**FEDERAL AVIATION ADMINISTRATION
AIRWORTHINESS DIRECTIVES**

**SMALL AIRPLANES, ROTORCRAFT, GLIDERS,
BALLOONS, & AIRSHIPS**

BIWEEKLY 2022-03

2021-26-16 Various Restricted Category Helicopters: Amendment 39-21875; Docket No. FAA-2021-0189; Project Identifier AD-2020-00645-R.

Figure 1 to the Introductory Text of Paragraph (g)(3) – Main Driveshaft Installation and Removal Tool

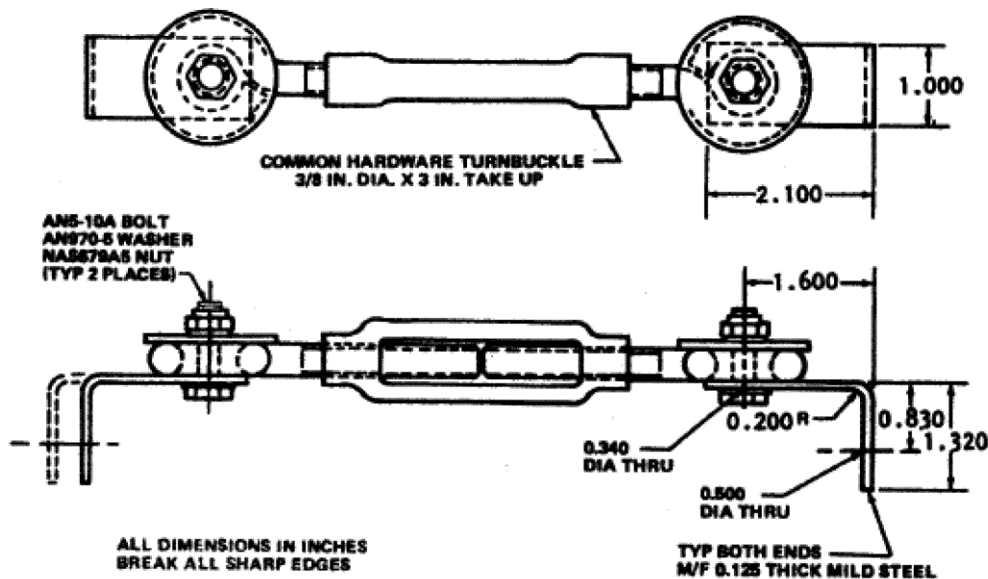
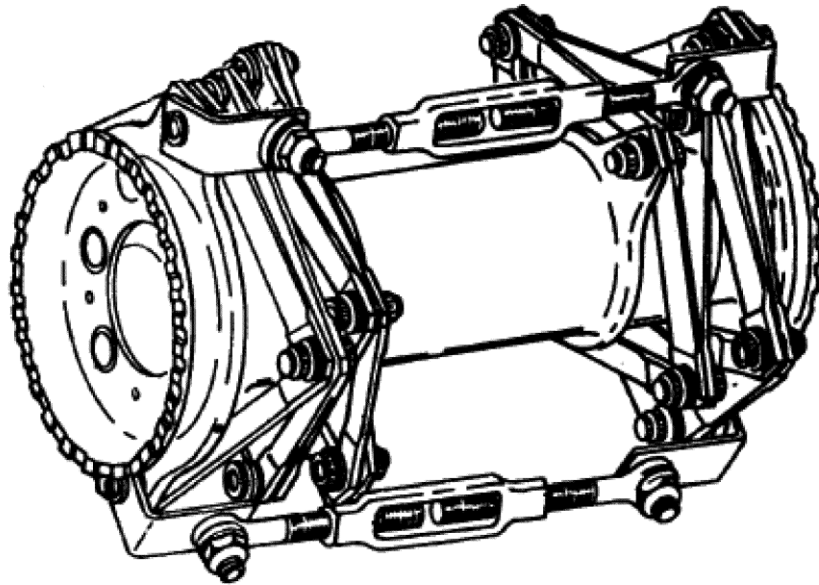
(3) Within 25 hours TIS after the effective date of this AD, remove main driveshaft P/N SKCP2180-1, SKCP2281-1, SKCP2281-1R, or SKCP2281-103 by following “6-24.3. Removal–Main Driveshaft P/N SKCP2281-103” on page 6-24, including “4-24. Removal–Air Inlet Filters” on page 4-17 and “Figure 4-9. Engine Air Inlet Filter Installation” on page 4-16, of Headquarters, Department of the Army, Aviation Unit and Intermediate Maintenance Instructions Army Model UH-1H/V/EH-1H/X Helicopters, Technical Manual TM 55-1520-210-23-1, Change No. 42, dated April 14, 2003 (TM 55-1520-210-23-1 C 42), except where instructed to “refer to figure 6-12.2” in TM 55-1520-210-23-1 C 42, refer to Figure 1 to the introductory text of paragraph (g)(3) of this AD, and where instructed to “see figure 6-12.3” in TM 55-1520-210-23-1 C 42, see Figure 2 to the introductory text of paragraph (g)(3) of this AD, and:

Note 3 to the introductory text of paragraph (g)(3): Figures 6-12.2 and 6-12.3 are missing from TM 55-1520-210-23-1 C 42.
